Metro Outer Development Assessment Panel Agenda

LOT 32 (1771), Lot 31 (1777), Lot 30 (1779) & Lot 29 (1783)
Albany Highway KENWICK WA 6107
Motor Vehicle Sales & Service Centre
Form 1 – Responsible Authority Report
(Regulation 12)

Approve DAP Application reference DAP/23/02573 and accompanying plans (Existing Site Survey - SK014 – 1000, Perspective Plan – SK014 – 4000, Perspective Plan – SK014 – 4001, Perspective Plan – SK014 – 0001, Perspective Plan – SK014 – 0002, Perspective Plan – SK014 – 0003 dated September 2023, Site & Ground Floor Plan – SK016 – 2000, Elevations – SK015 – 3000 dated December 2023, in accordance with Clause 68 of Schedule 2 (Deemed Provisions) of the *Planning and Development (Local Planning Schemes) Regulations 2015*, and the provisions of Town Planning Scheme No. 6, subject to the following conditions:

- Attachment 1 - Extract of Land Protect Plan No 201432-0111
- Attachment 2 - Extract of Carriageway Pattern Plan Drawing No. 201432-0107
- Attachment 3 - Marked up development site plan dated 2 February 2024

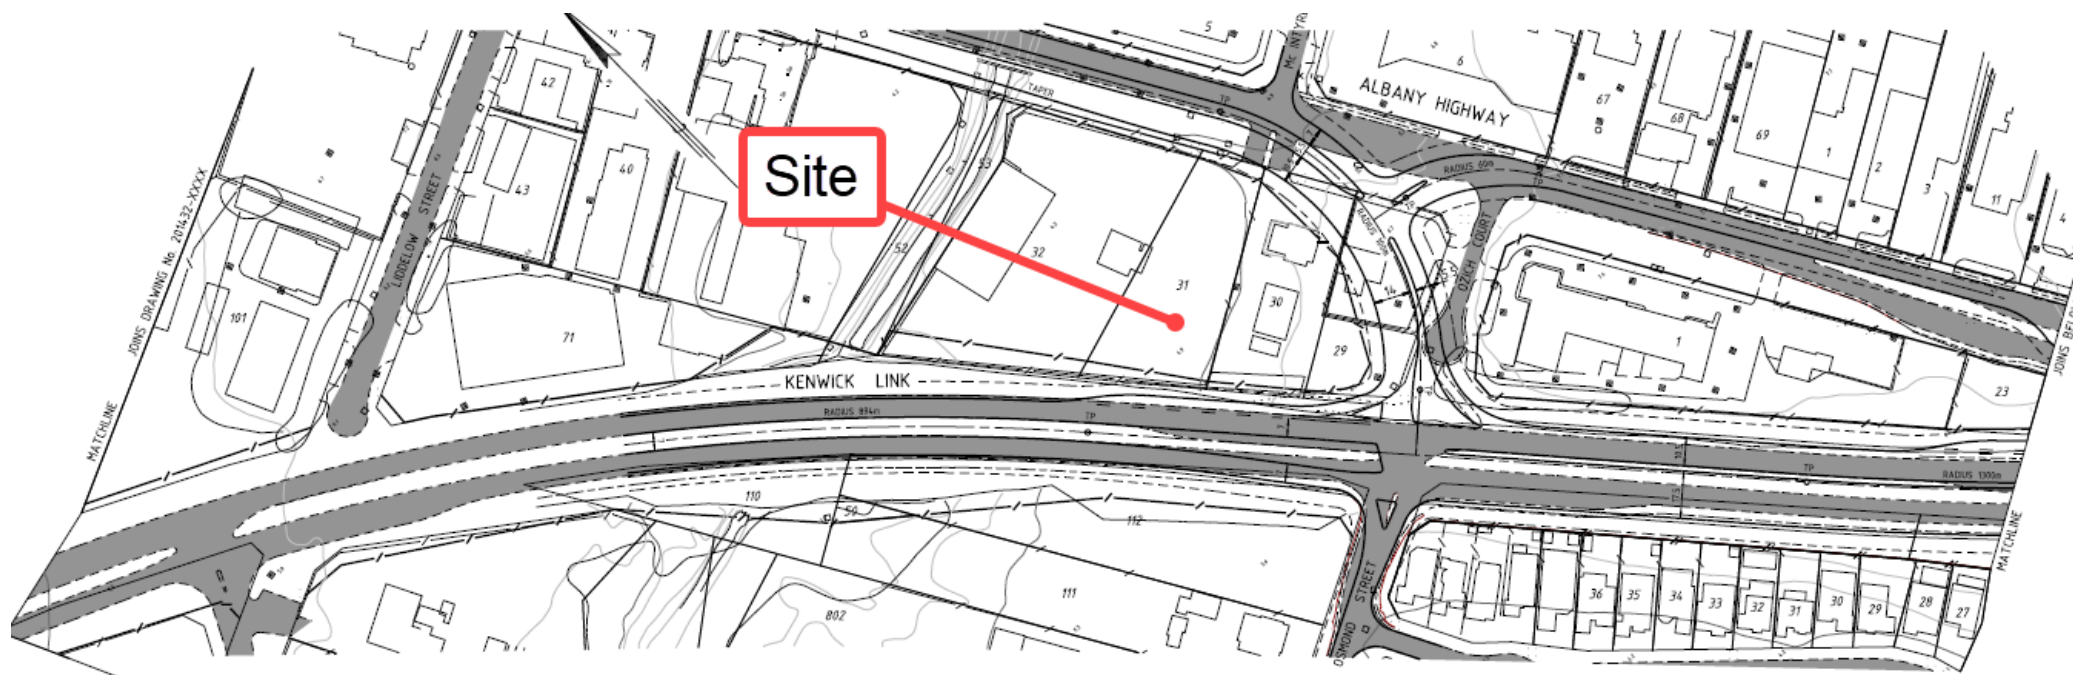
6. Prior to the occupation of the development, the land required for the widening of Albany Highway and Kenwick Link as shown on Land Protection Plan No 201432-0111 (refer Attachment 1) is to be set aside as a separate freehold lot for acquisition pending future road widening requirements.

7. Any development within the land required for future road purposes, as shown on Land Protection Plan No 201432-0111 (refer Attachment 1), shall only be permitted for the purposes of car parking, signs and landscaping.

8. In the event the land required for future road purposes as shown on Land Protection Plan No 201432-0111 (refer Attachment 1) is needed for future roadworks, the landowner shall upon receipt of a notice from Main Roads, relocate or remove the development at the cost of the landowner.

MAIN ROADS MARKED-UP PLAN
AMENDED IN RED 2 February 2024

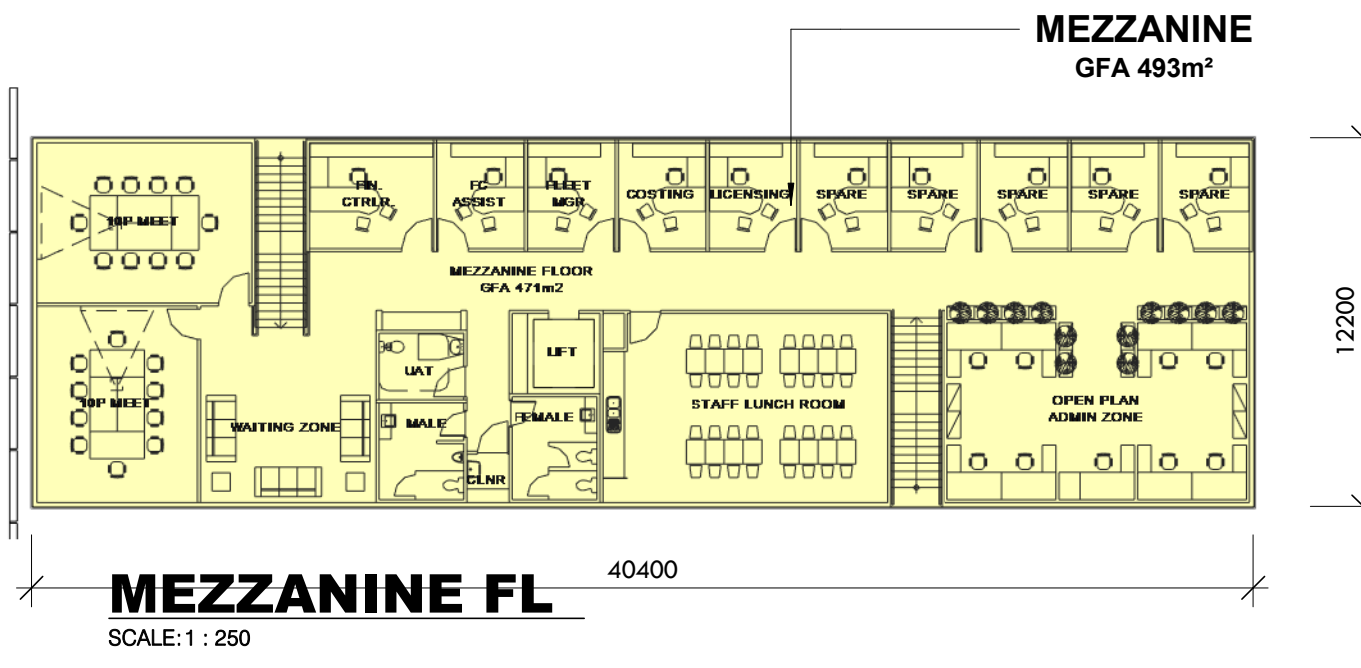
In response to correspondence received on 3 January 2024, please be advised Main Roads has reviewed the information and is unable to support the proposed access arrangements on Albany Highway in its current form.

The access arrangements as proposed are not supported by Main Roads. As discussed, the road authority can only support a left out only arrangement at the southern crossover and full movement access at northern crossover. Revised plans are required to conform to Main Roads requirements to ensure the development access arrangements are achieved.

1. Prior to the issue of the building permit an amended development plan is to be submitted and approved identifying the following access arrangements to Albany Highway.
 - The northern vehicular crossover on Albany Highway is to be reconfigured for full movement turning.
 - The southern vehicular crossover on Albany Highway is to be reconfigured for left-out turning only.
 - Removal of the median strip as identified on plan.

This plan shall be to Main Roads requirements and the satisfaction of the City.
